Appendix F1 Meeting Minutes and Discussion Paper for the Meeting with Planning, Works and Housing Committee of the Eastern District Council on 29 November 2016

東區區議會轄下 規劃、工程及房屋委員會 第六次會議紀錄

II. 東區走廊下之行人板道研究 - 第二階段社區參與

Boardwalk underneath Island Eastern Corridor Study Stage 2 Community Engagement

Recommended Scheme of the Boardwalk - Master Layout Plan

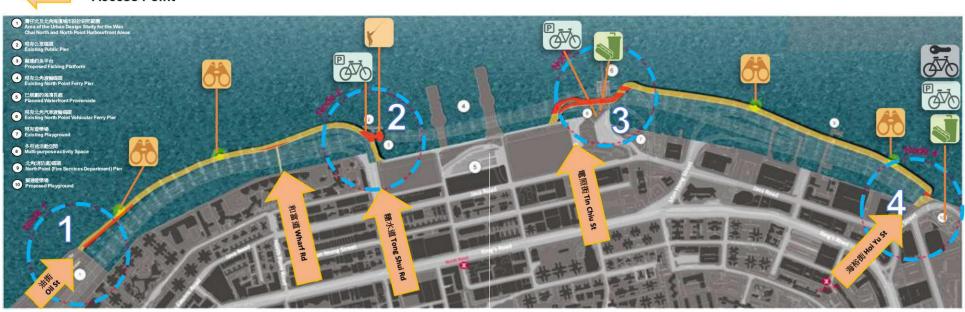
- (k) <u>林翠蓮</u>委員感謝署方優化板道設計,並增加暢達性。她建議署方設立自動租借單車設施,避免市民利用私人單車往返板道,保障道路安全。她另提醒署方特別注意板道藝術裝置的管理,包括日常清潔及維修保養等工作,並必須提供洗手間設施。她建議署方日後再詳細考慮救護設施的安排;
- (I) <u>洪連杉</u>委員認同有必要興建板道,請署方確保工程符合法例要求,避免工程受到阻延。他希望署方可於城市花園增加額外的連接點,以加強海濱的可達性。此外,他支持增設單車徑,建議日後再詳細討論具體運作細節。他亦關注工程的時間表,詢問署方預計完成工程的日期;

- (p) <u>蔡素玉</u>委員表示板道計劃已早於十多年前開始討論,現欣見計劃 有初步進展。為方便市民前往板道,並於有需要時提供緊急疏散出 口,她建議署方增加更多的連接點。即使現階段未能解決業權問 題,署方亦應預留空間作將來發展之用;
- (q) <u>李進秋</u>委員支持興建板道,期望署方早日落實工程計劃,方便市 民及遊客享用海濱。她認為板道設計美觀,但擔心嬉水區日後因意 外事故而暫停運作,令整體美觀及營運效果未如理想。此外,她亦 贊成增設單車徑,為海濱地段提供更多康樂設施;

- (x) <u>趙資強</u>委員表示計劃討論多時,為免計劃進一步延期,他希望署方盡快分階段落實工程計劃,先進行爭議性較低的工程,使市民早日享用設施。他另建議署方增加更多的連接點,如遇緊急事故可更有效疏導人流;
- (y) <u>楊斯竣</u>委員支持板道計劃。他引述鰂魚涌公園的例子,指木製的 行人板道容易破損,維修工程亦需時,希望署方在挑選物料時加倍 注意。他另詢問行人及單車使用者的分隔措施,以及單車租借亭的 運作方式;以及

- 5. 土木工程拓展署 麥志標 先生就委員的意見及提問,回應如下:
 - (a) 署方在《第一階段社區參與》收集的公眾意見,有助署方按《保護海港條例》的規定,確立擬建行人板道的凌駕性公眾需要。除一般公眾人士外,署方亦取得部分保護海港關注團體的支持。署方將於下一階段擬備「有力和令人信服」的資料,制定合適的行人板道建議方案,確保工程符合《保護海港條例》的要求,預計最快可於2018年展開詳細設計工作,隨後便會申請撥款,期望盡快展開工程,並於數年後落成;
 - (b) 如單車徑及釣魚區的建議獲得確立,署方將參考全港其他單車徑及 釣魚區的運作及管理經驗,制定使用條款。署方亦會參考其他單車 亭的營運經驗,研究引入智能租借單車設施;
 - (c) 署方關注行人板道使用者的安全,並會在詳細設計和建造階段進一步深化及完善板道的結構設計,如分隔騎單車人士和行人的需要及措施、其他設施的景觀和建築設計等。署方亦會特別小心挑選合適的建築物料,以確保行人板道的質素。擬建的嬉水區只會提供水氣霧化設備,以營造氣氛,並不會影響使用者安全;
 - (d) 為加強行人板道與內陸之間的連接,署方會在和富花園現有的海濱 休憩用地提供一個額外的連接點通往行人板道。但由於城市花園段 涉及私人地段,城市花園的連接點只能應付緊急需要。署方亦會檢 視加設救護站的可行性,並尋找合適地點;
 - (e) 署方已於網上設立專頁及社交網站連結,亦已印製宣傳單張及海報,以加強宣傳效果。署方歡迎各委員及公眾積極參與第二階段的公眾參與活動;以及
 - (f) 本計劃的行人板道屬《港島東海旁研究》的一部分,日後政府將繼續落實海濱的長遠發展。
- 6. 梁國鴻 主席總結時請委員踴躍支持題述活動。
